URGENT Medical Device Correction

Trilogy Evo, Trilogy Evo O2, Trilogy Evo Universal, and Trilogy EV300
Flow Sensor Nebulized Aerosol Deposition

03-October-2024

Figure 1: Acceptable In-Line Nebulizer Placement.

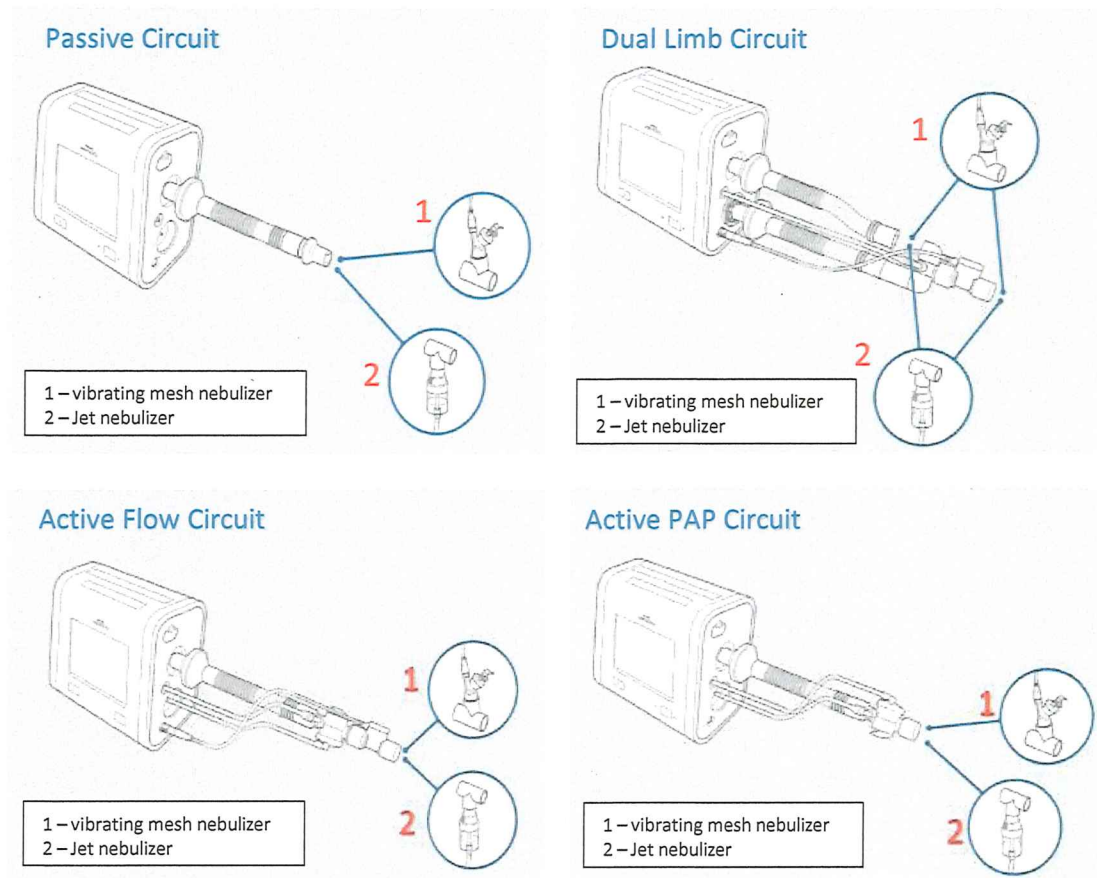
- When the in-line nebulizer is used with passive circuits for tidal volumes greater than or equal to 700 mL, or
- When the in-line nebulizer is placed at the dry side of the heated humidifier, or
- When the in-line nebulizer is placed at the “inspiratory port (to patient)” (device outlet), or
- When the in-line nebulizer is placed in any location *other than* those identified in the images in Section 4

- If using in-line nebulizer treatments:
 - The circuit must be configured as pictured in the images in **Figure 1** below
 - For prescriptions needing tidal volumes greater than 700 mL with a passive circuit, transition patient to alternate circuit (Active PAP, Active Flow, or Dual Limb).
